Title: eCE Bus and eMV Calibration Release Information

Applies To: eCE Bus and eMV

IC Bus® Electric CE Series and International® eMV™ Series VCU calibration release information:

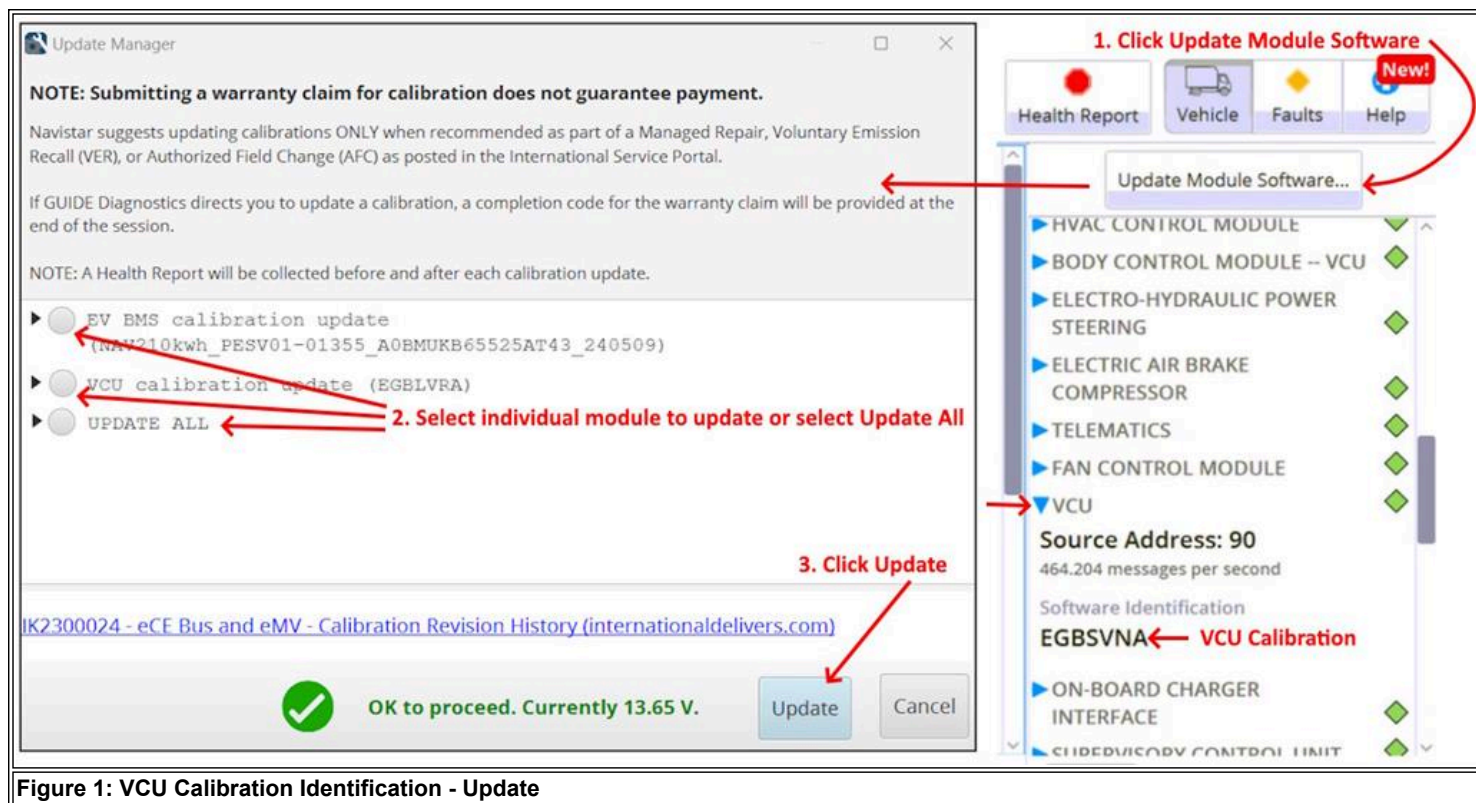
- Improved energy efficiency
- Updated charge port LED indicators.
 - See chart below.
 - New charge port door decal. [Sample Decal](#)
